AGENDA
CITY OF KENTWOOD PLANNING COMMISSION
TUESDAY, JANUARY 24, 2023
KENTWOOD COMMISSION CHAMBERS
4900 BRETON AVENUE
7:00 P.M.

STAFF REPORT: January 19, 2023
PREPARED FOR: Kentwood Planning Commission
PREPARED BY: Joe Pung
CASE NO.: 4-23 Snackcraft Building Addition

Re: **Snackcraft Addition**
4444 52nd Street SE
41-18-36-200-033
Review of Site Plan Received 1-3-2023

Exhibit 8: Existing Pathway Along Broadmoor Avenue

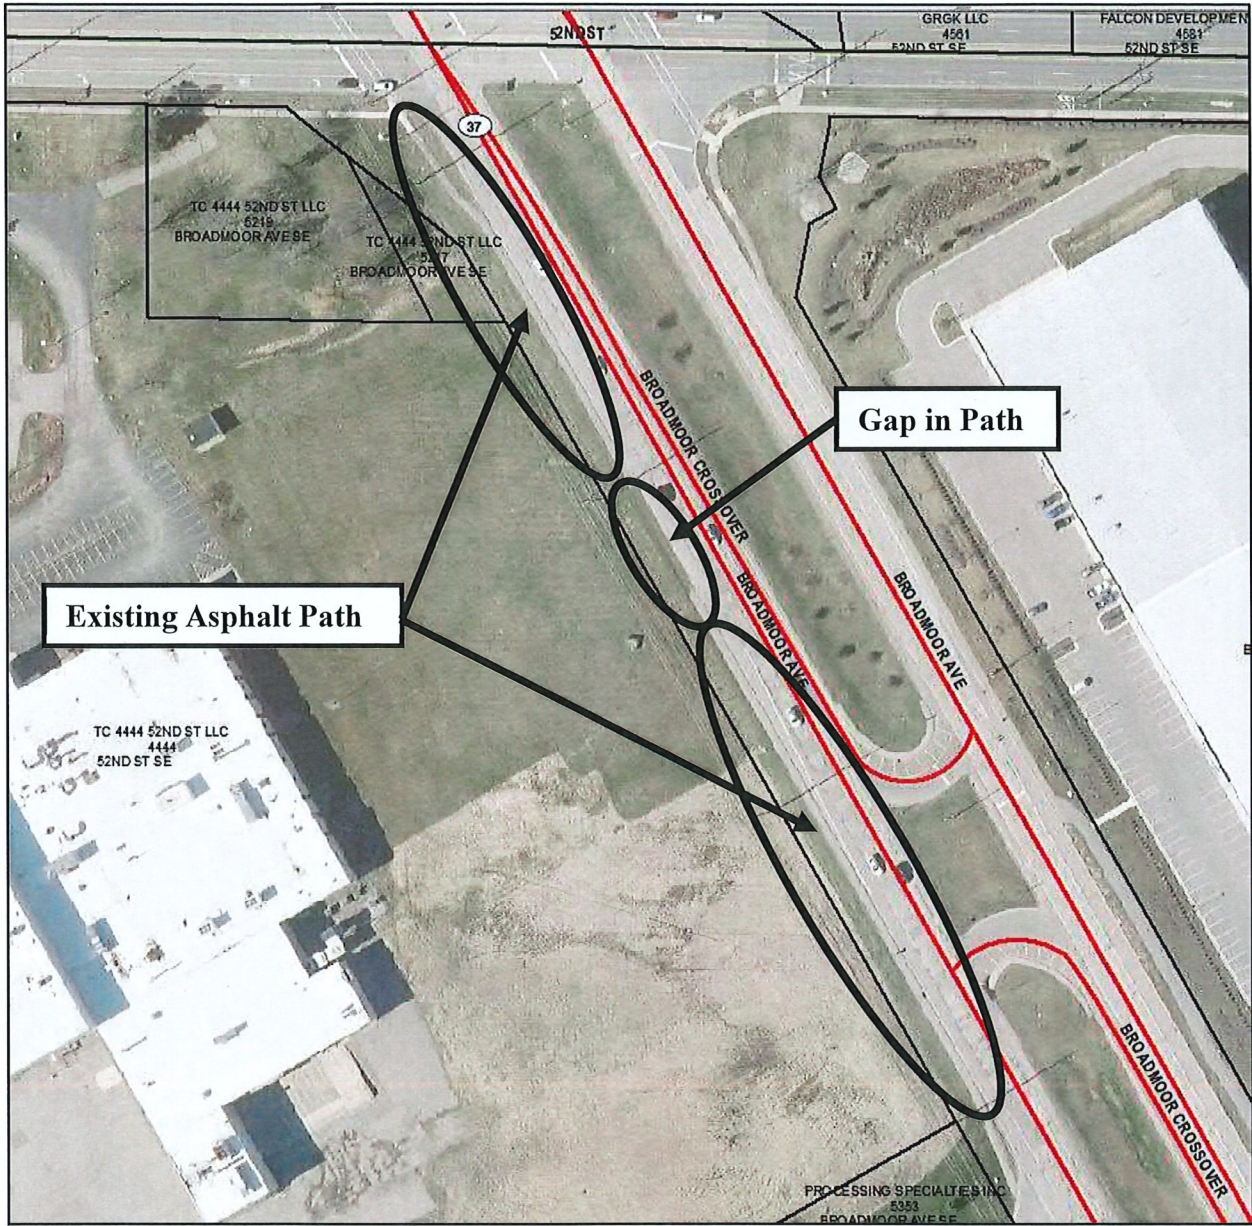
The City of Kentwood Non-motorized Plan calls for a 10-foot wide shared use path along Broadmoor Avenue. There is currently an incomplete (gap of approximately 90 feet) approximately 5-foot wide asphalt path along Broadmoor Avenue (see Exhibit 8); the existing path will need to be expanded to a width of 10 feet and the gap filled.

4 WEST ELEVATION
A0-1 SCALE: 1" = 20'-0"

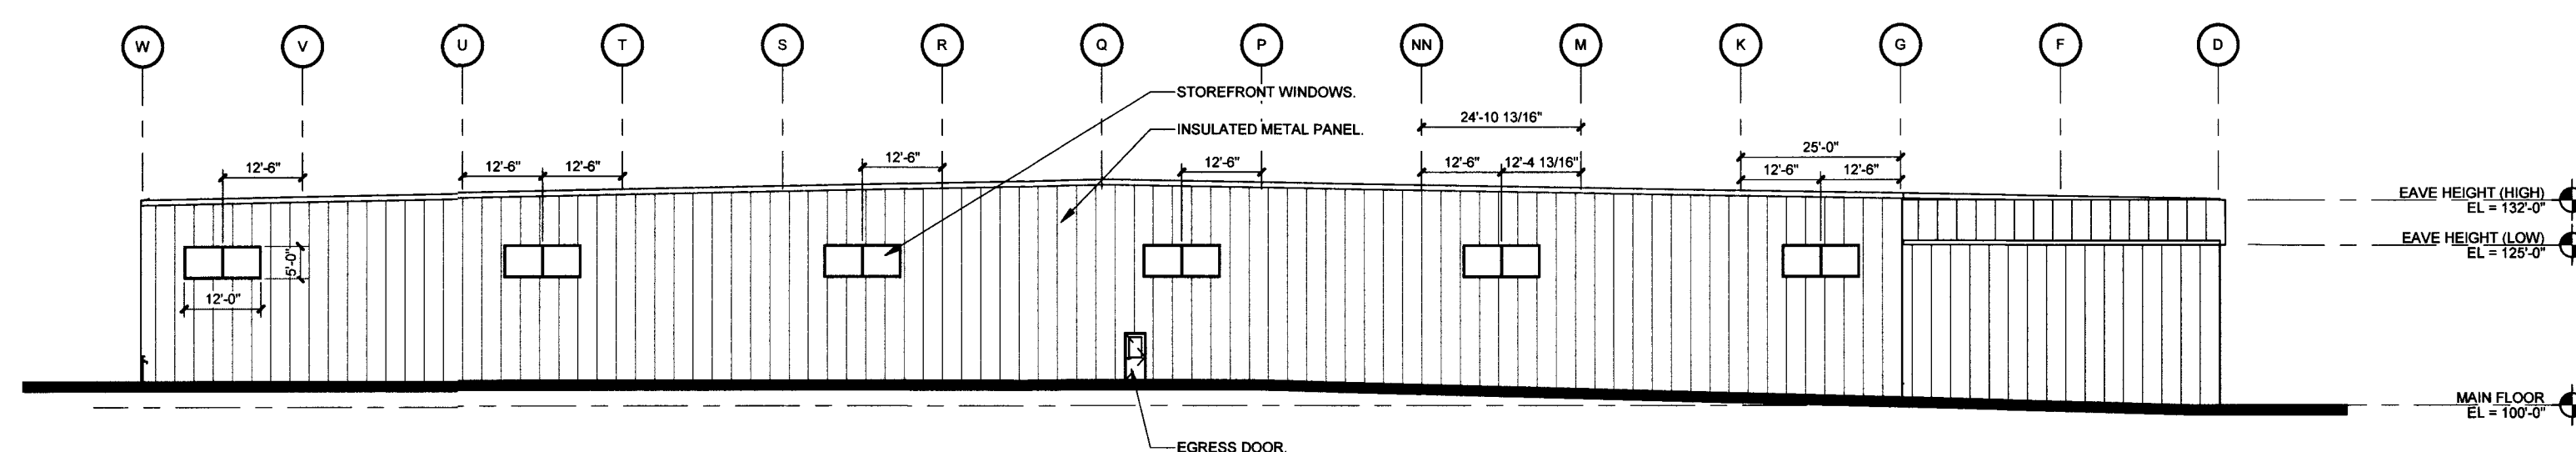
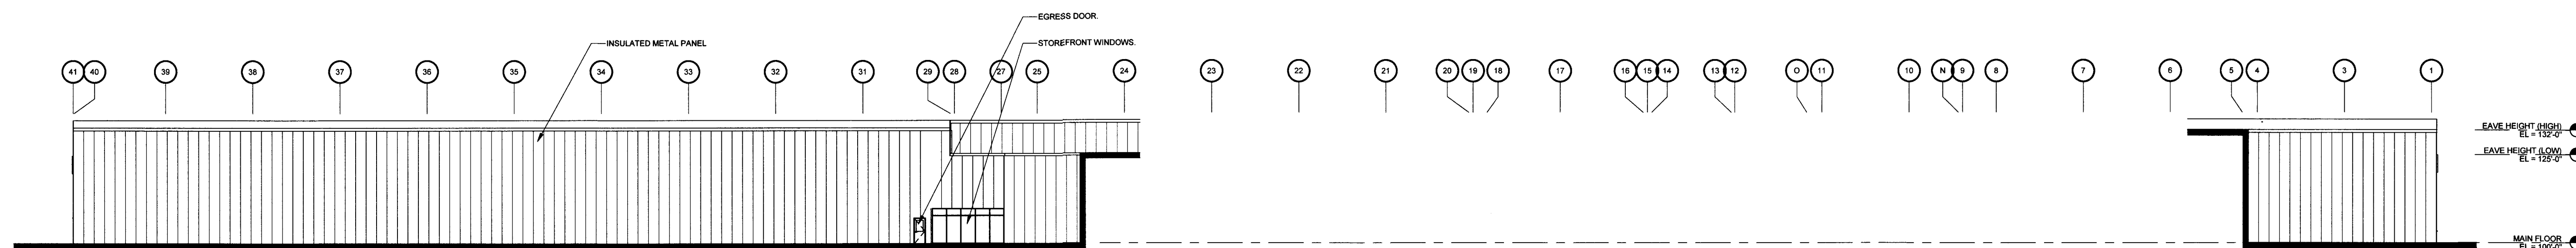
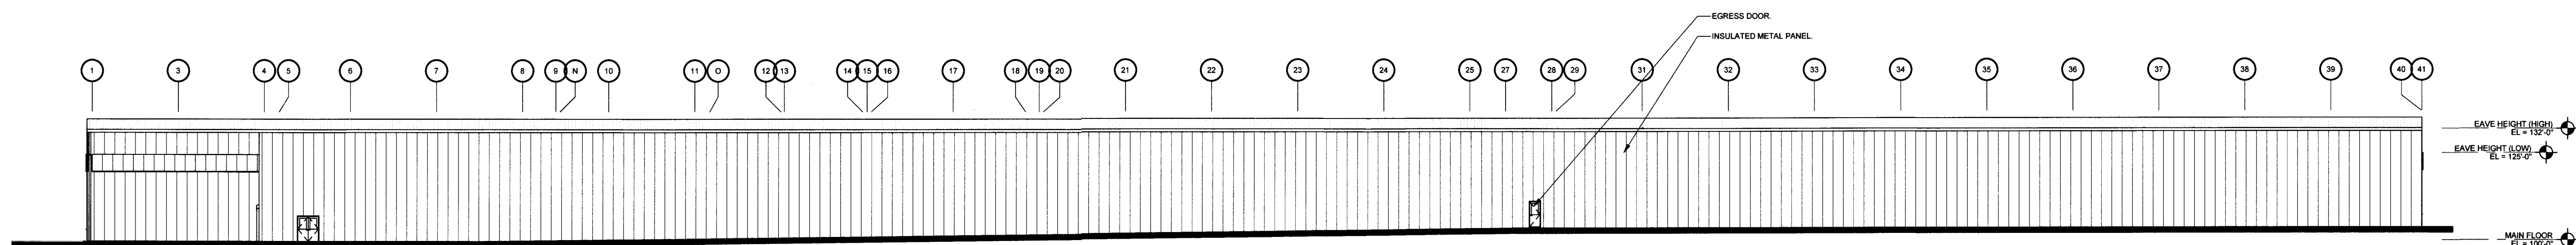
- 4) A condition of the original preliminary site plan approval was for Planning Commission review and approval of the architecture for the redevelopment and expansion of the existing industrial building. The exterior of the proposed addition would consist primarily of insulated metal panels. The Zoning Ordinance currently limits metal composite material panels to 75 percent and requires that the predominant material utilized on facades visible from a public right-of-way or parking lot be brick. Staff has reached out to the City Attorney to determine if the development would be held to the current building material standards; if so, the applicant would need to revise the building materials or request a waiver from the requirement.

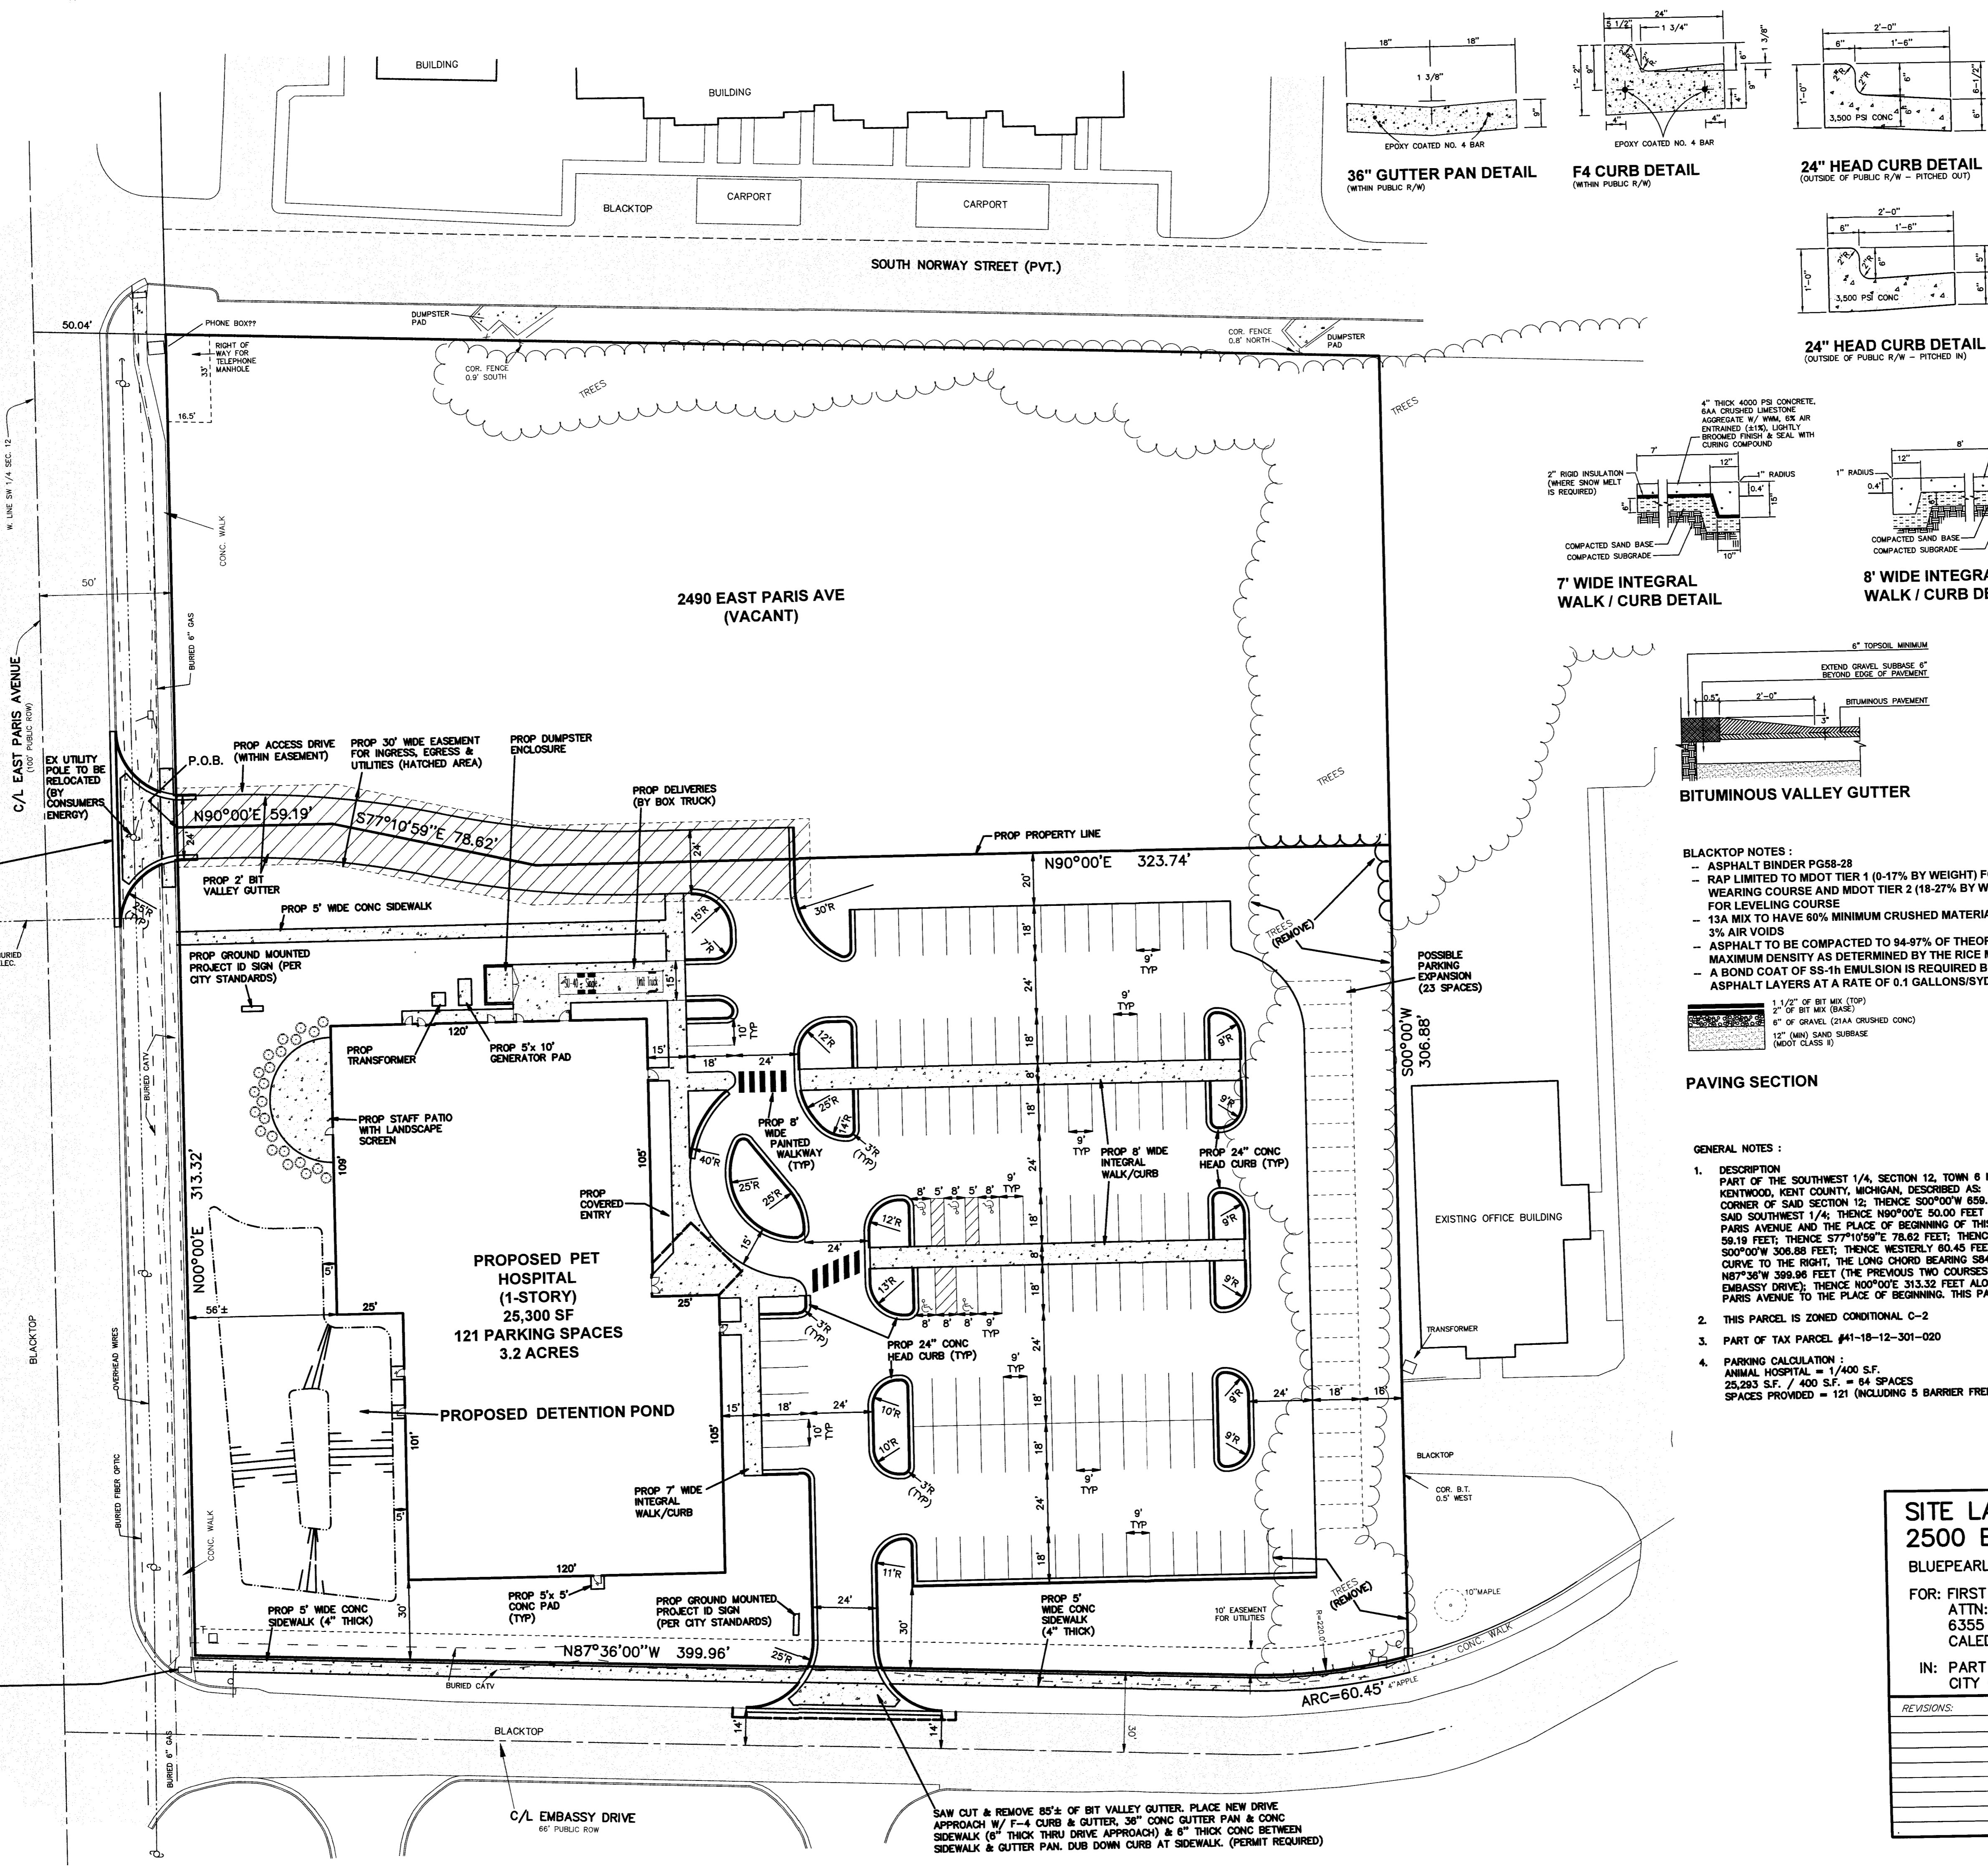
- Apparent need for Traffic Impact Assessment
- Discuss need for parking in excess of minimum requirements
- Modify tree selection along the East Paris Avenue frontage
